Response to NRC Post-Fukushima Recommendations

1D Response to NRC Post-Fukushima Recommendations

Figure 2.2.6 Remote Shutdown System

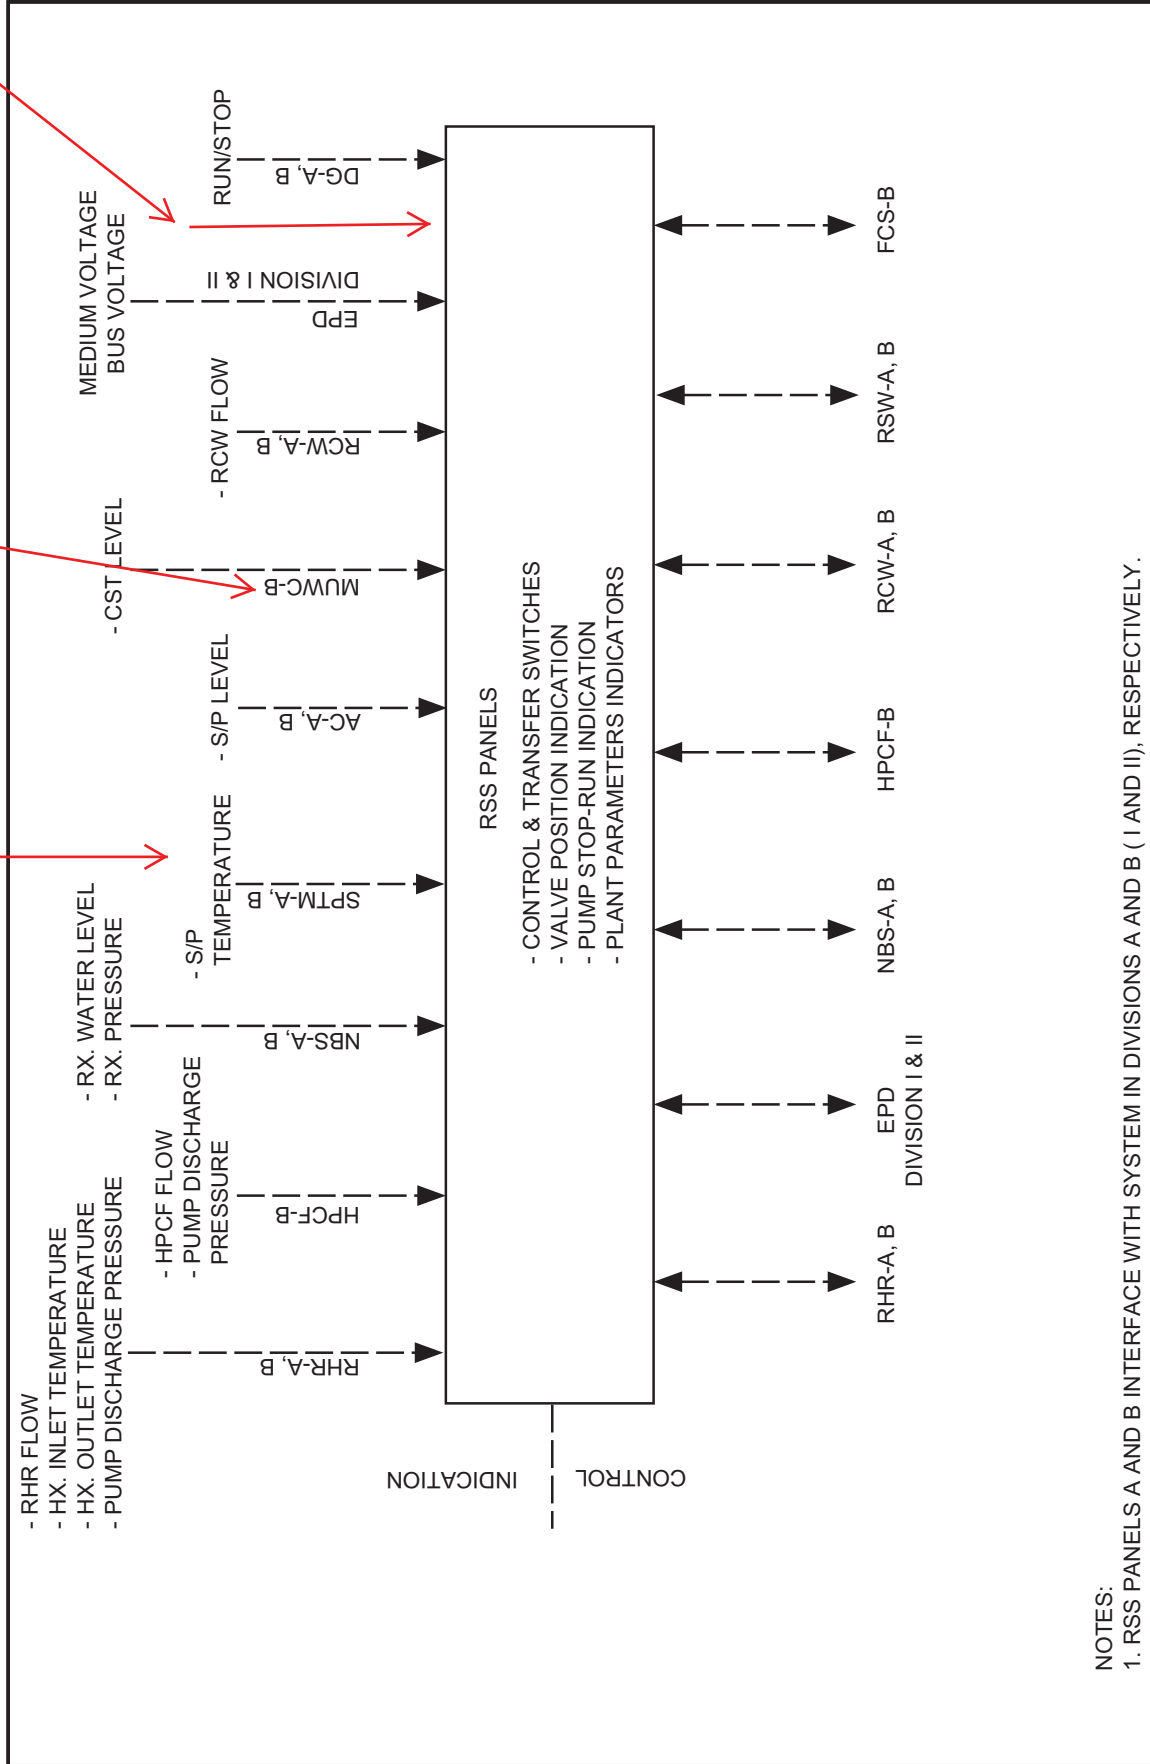
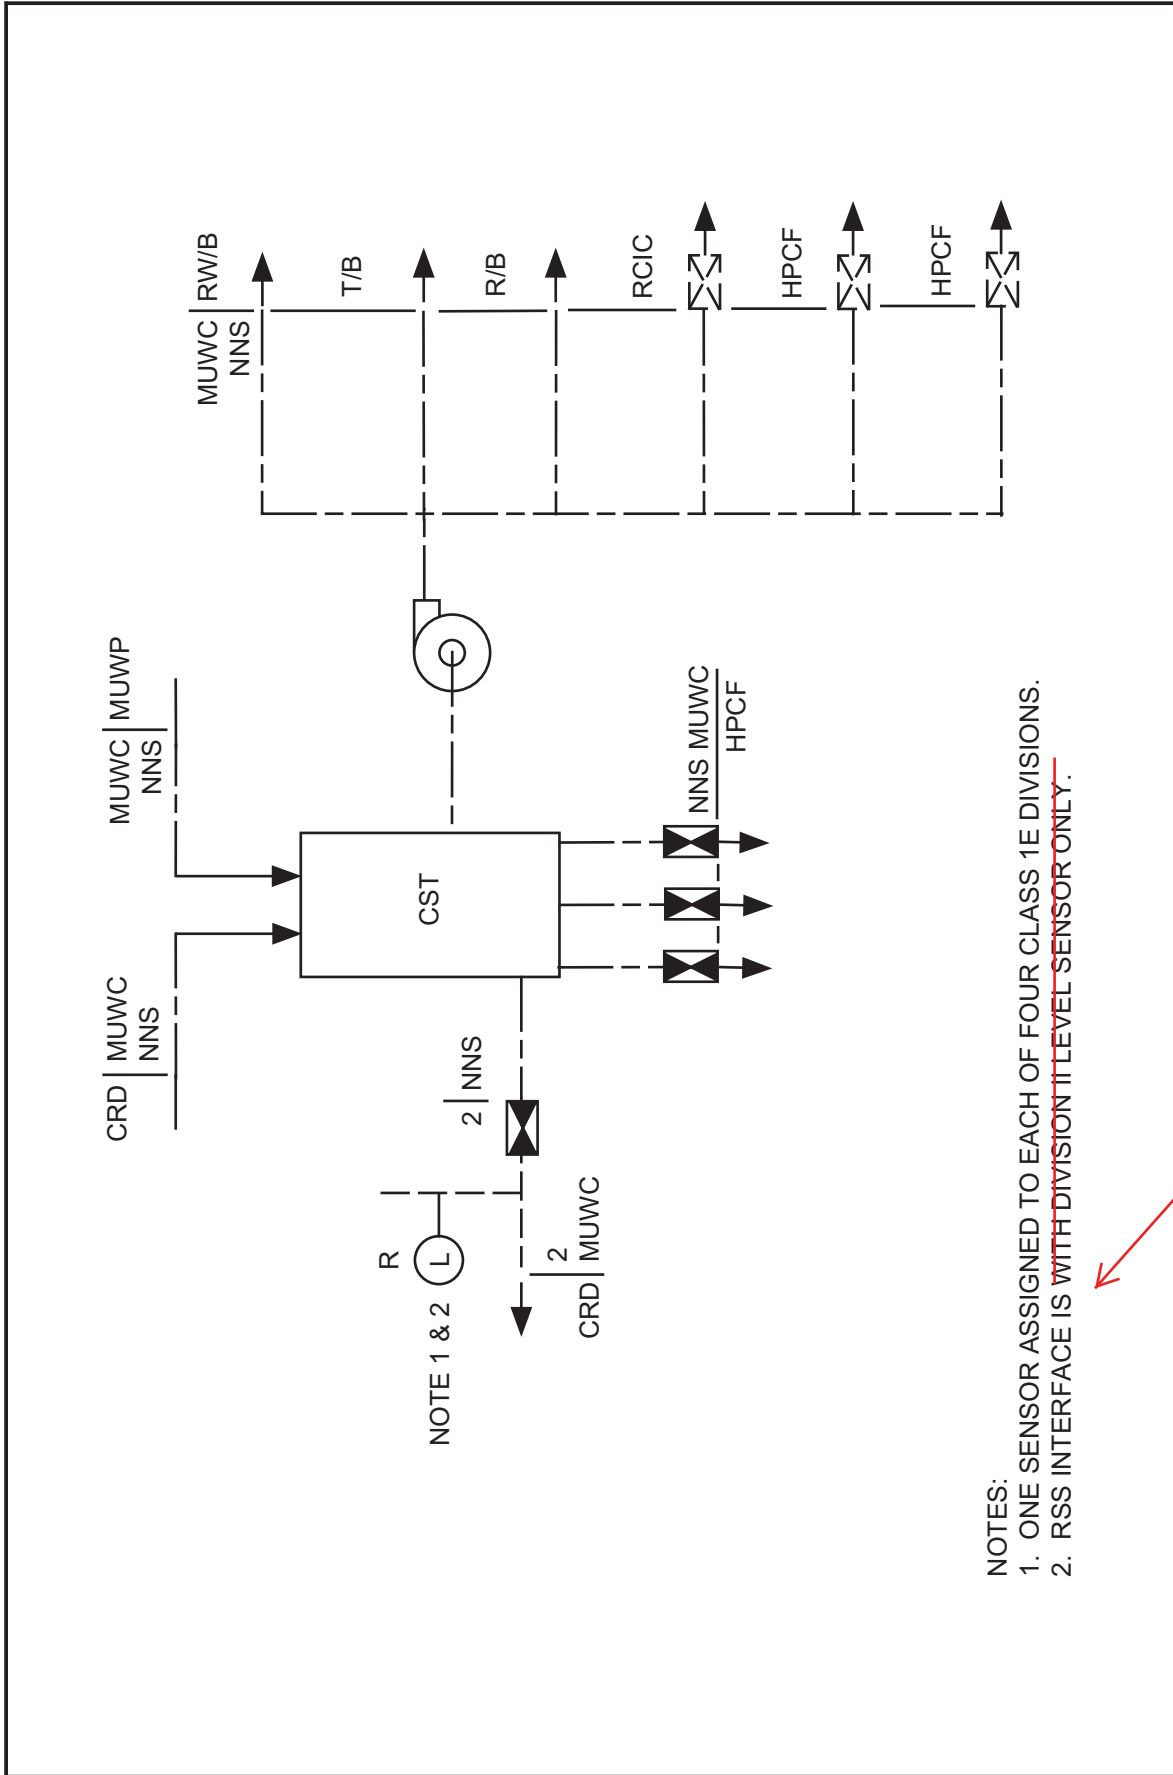
(12) High Pressure
Nitrogen Gas
Supply System

HPIN A, B Pressure

Add Drywell Pressure

Add A
